Title of Change:	FDN304P Missing P Character in Product Laser Marking.
Effective date:	19 Sep 2022
Contact information:	Contact your local onsemi Sales Office or KrisJudelo.Dayna@onsemi.com
Type of notification:	This Product Bulletin is for notification purposes only. onsemi will proceed with implementation of this change upon publication of this Product Bulletin.
Change Category:	Others
Change Sub-Category(s):	Shipping/Packaging/Marking

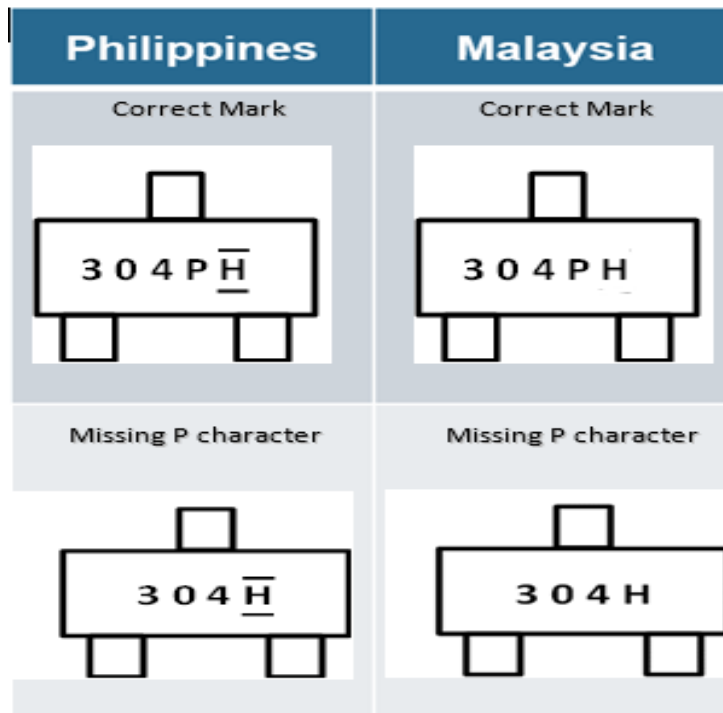
This is to inform that we have a cosmetic (marking) issue on the product FDN304P.

FDN304P has 2 assembly sites, onsemi Malaysia and onsemi Cebu, Philippines both sites had same marking error – missing the “P” character.

See below for illustration for reference.

We have taken corrective action to correct the error at our Malaysia and Philippines production sites last May 11,2022.
